SUBDIVISION COMMITTEE
METROPOLITAN AREA PLANNING COMMISSION

STAFF REPORT
(Final Plat, Preliminary Plat Approved 4/29/93)

CASE NUMBER: S/D 93-21 - GRIFFIN PARK 2ND ADDITION

LOCATION: Northeast corner of Hydraulic and 57th Street South

VICINITY MAP:

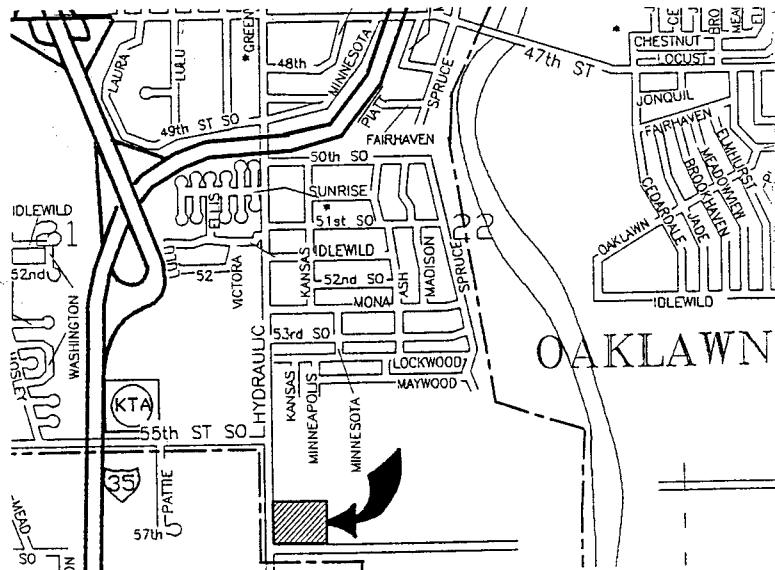
NOTE: A zone change (Z-3087) from "AA" one-family to "E" Light Industrial zoning has been approved for this site. While during the zone change review, it was not indicated that a two-lot plat was being considered, this preliminary does indicate two lots. Access to one of the lots is, however, indicated by means of a street (57th Street South) which is below the right-of-way standard for industrial-type streets and is also paved to a standard below what is required of streets providing access to industrial property.

As is indicated by this plat, 57th Street South was obtained by condemnation and apparently came from the property south of this proposed plat. At this time, the sole purpose of 57th Street appears to be the provision of access to the City of Wichita's water plant located east and south of this site. Immediately south of this plat (south of 57th Street) is an area of County "R-1" Suburban Residential zoning. Typically, an industrial site should not use or have access to a street intended for residential uses. However, because of the conditions surrounding the tract south of this plat, it is not likely that this tract would or even should develop for residential purposes.

- D. On the final plat tracing, complete access control shall be indicated, on the face of the plat, across this Addition's south property line. This 15-foot drainage dedication shall also be indicated as street dedication.

- E. In the event that a public street is established along this site's south property line (57th Street South) a 20-foot building setback needs to be shown along the south lines of Lots 2 and 3.
